Re: **BID ADDENDUM No. 2**
Phase 1A – Bond Improvements
Bedford Central School District
SED No. 66-01-02-06-0-003-021 (FLHS)
SED No. 66-01-02-06-0-007-011 (FLMS)
SED No. 66-01-02-06-0-006-015 (MKES)
SED No. 66-01-02-06-0-002-016 (BVES)
SED No. 66-01-02-06-0-004-020 (BHES)
SED No. 66-01-02-06-0-009-014 (WPES)
SED No. 66-01-02-06-0-001-016 (PRES)
BBS File No 22-225A-G

The following changes shall be and are hereby made:

4 MAIN BUILDING ENTRY NEW ELEVATION
SCALE: 1/2" = 1'-0"

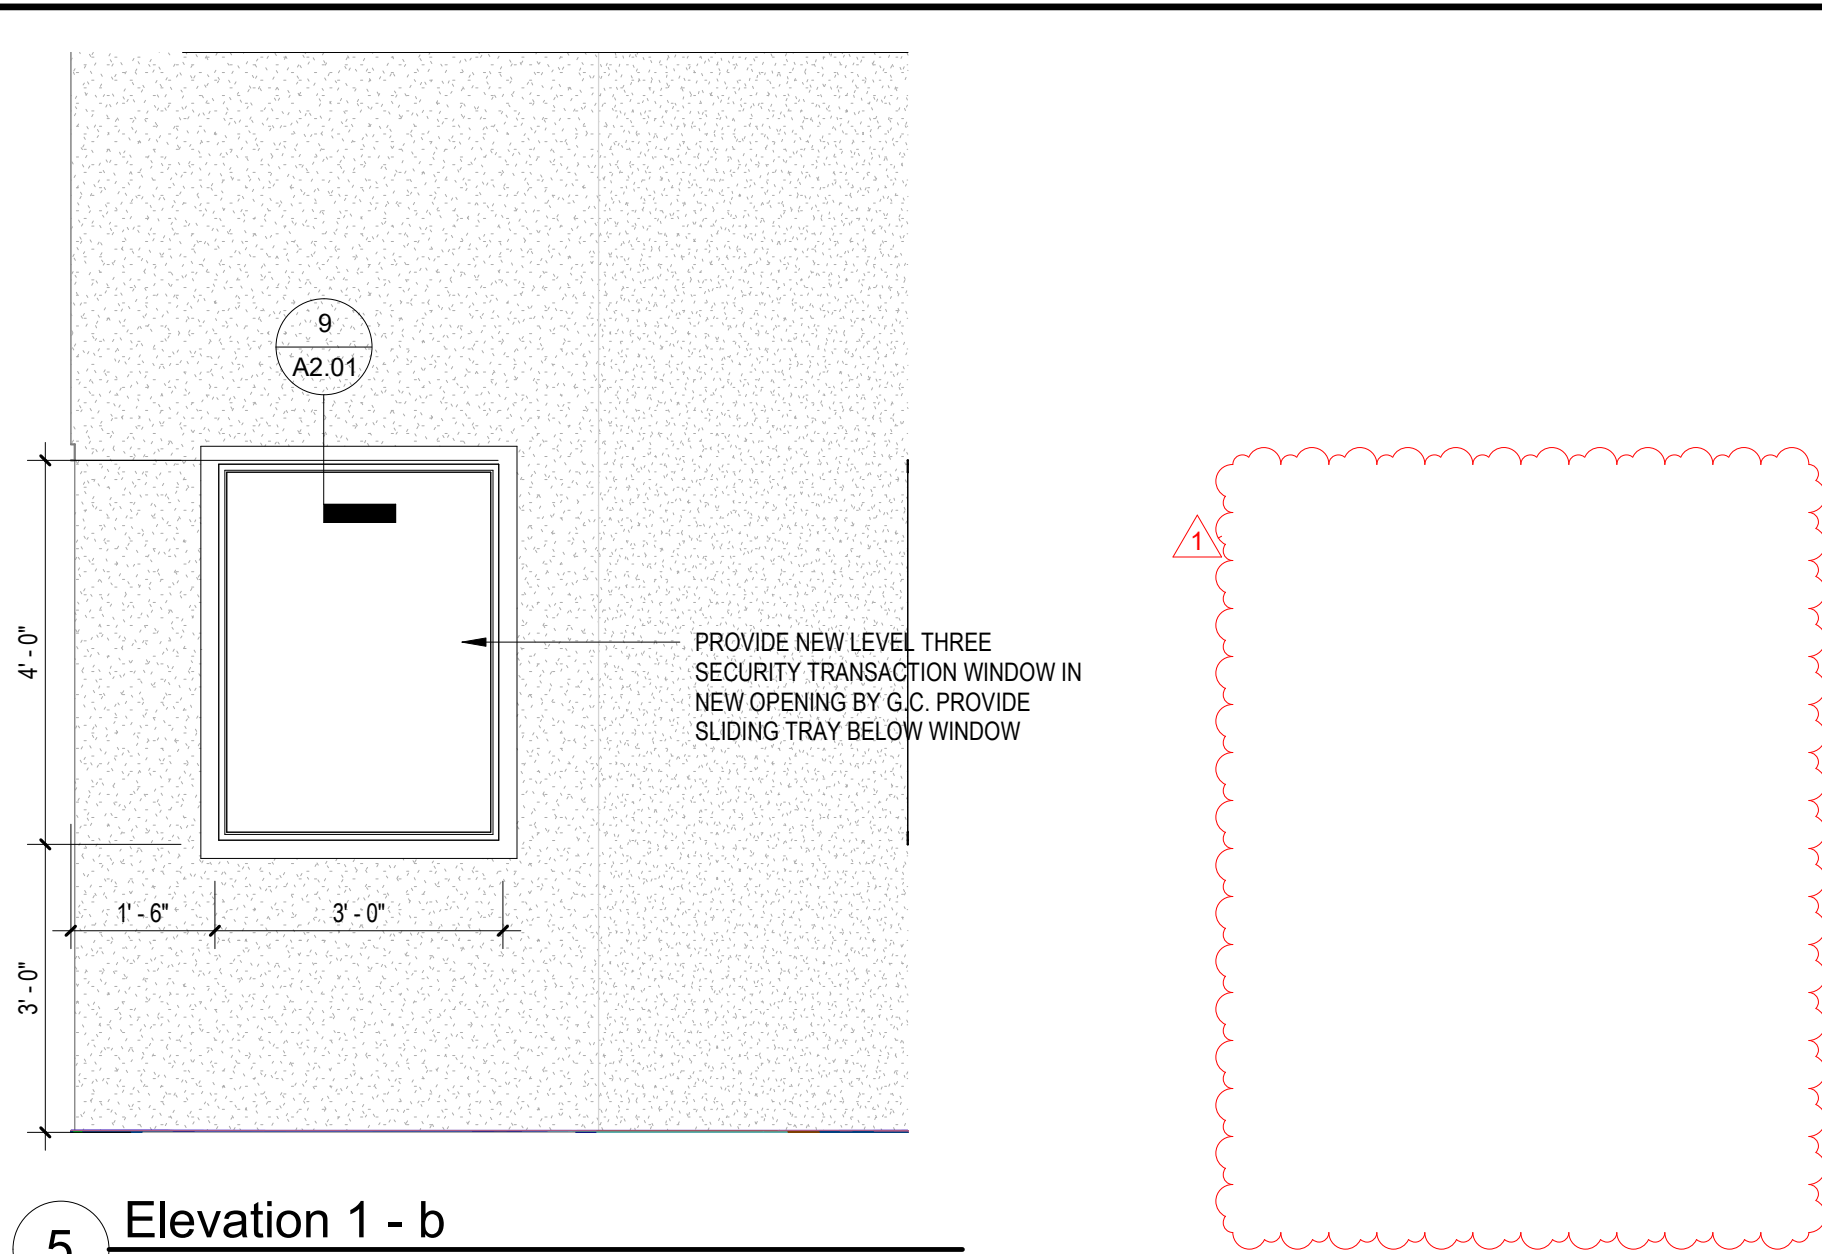
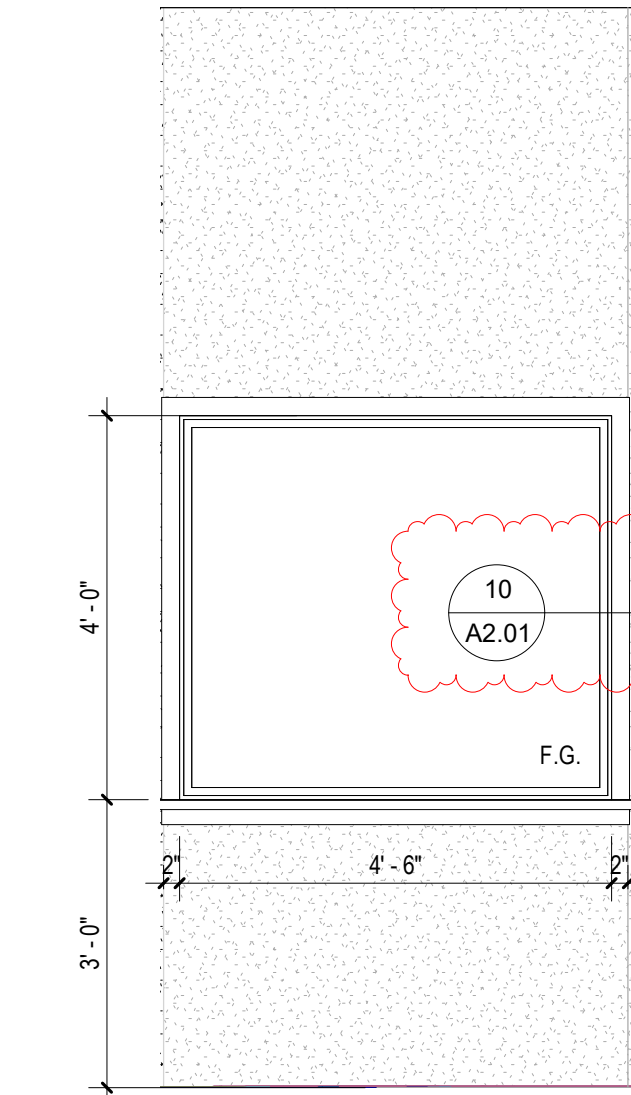
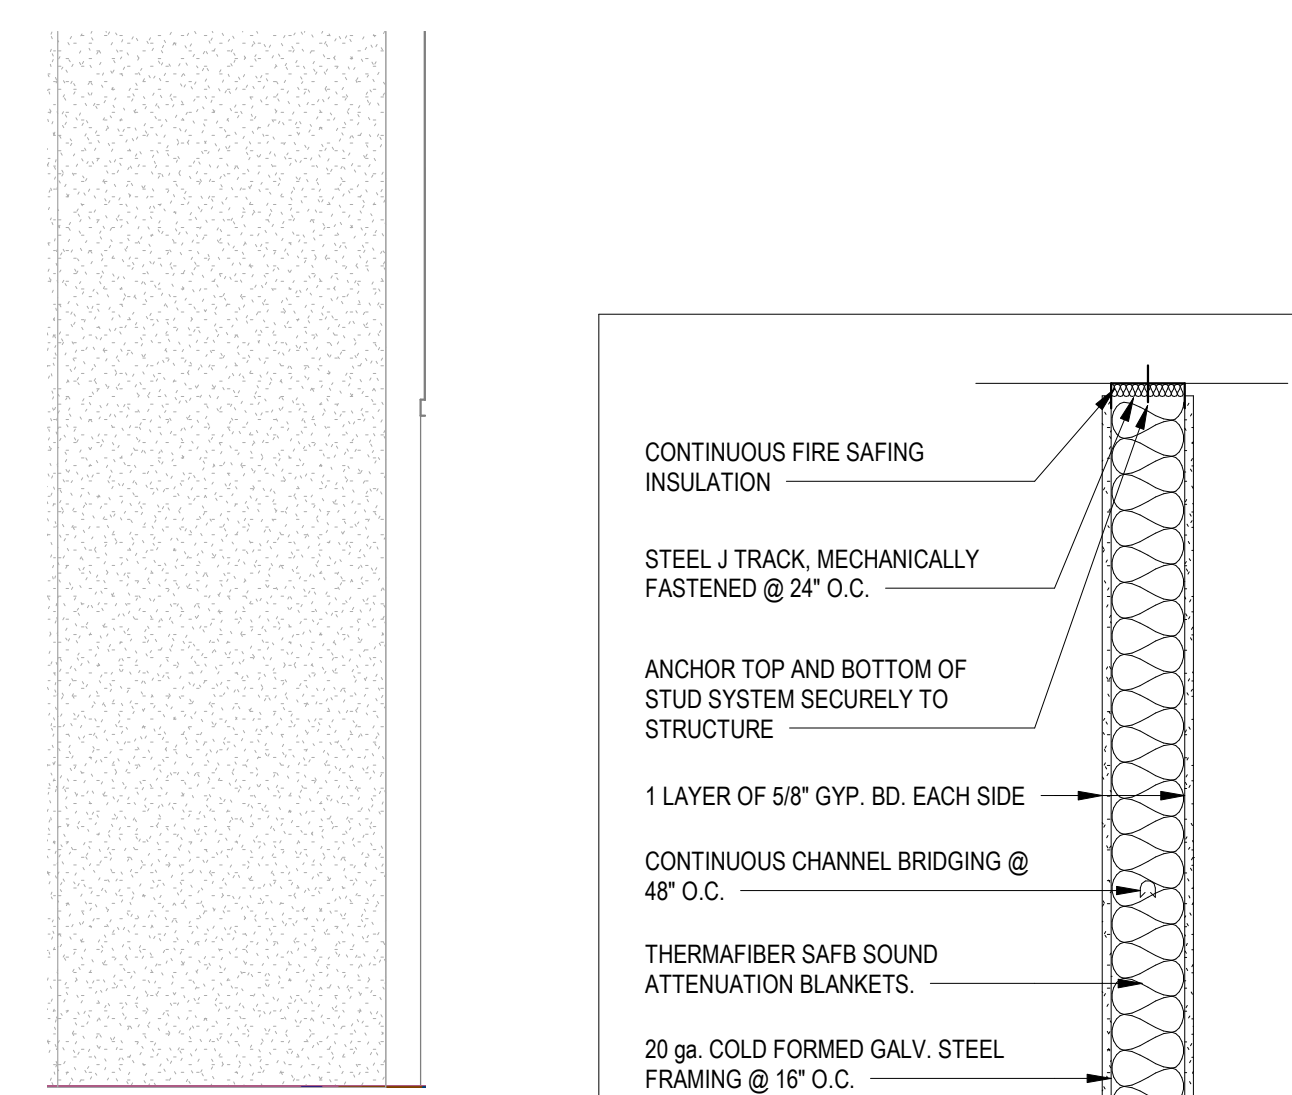
Drawing A1.01 MKES, section 3 notes existing drywall ceiling and VCT floor to remain and protect. Drawing A2.01 MKES, section 1 and 3 shows new ACT drop ceiling and LVT/VCT/T1 floor finishes. Please confirm existing ceiling and walls remain and new finishes installed over existing.

Please provide details for new concrete walk on A2.01 MKES, section 2.

MKES -_A2.01 Please provide drawings, sections, details and specifications for new concrete walk

BBS Response: Refer to revised drawing.

BBS Response: Concrete walk shall be omitted. Refer to revised drawing in this addendum.

BBS Response: Concrete walk at Mt. Kisco shown on A2.01 shall be omitted from bid.

6 Elevation 1 - c
SCALE: 1/2" = 1'-0"

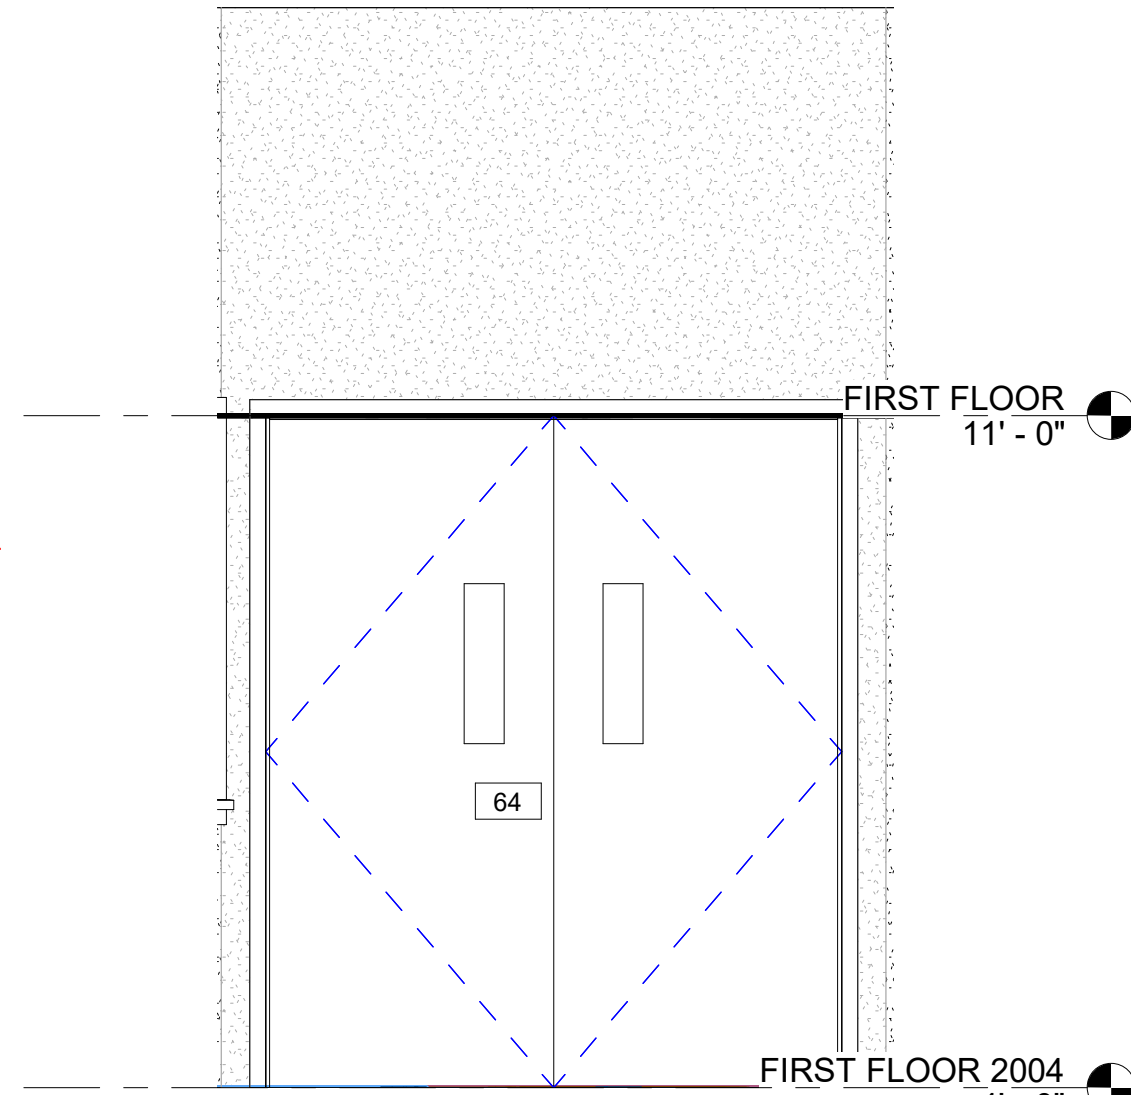
Drawing A2.01 MKES, section 6 Elevation 1-c shows new window, this is not on the schedule. Please confirm frame is HM and 20 min fire rated

BBS Response: Refer to revised drawing.
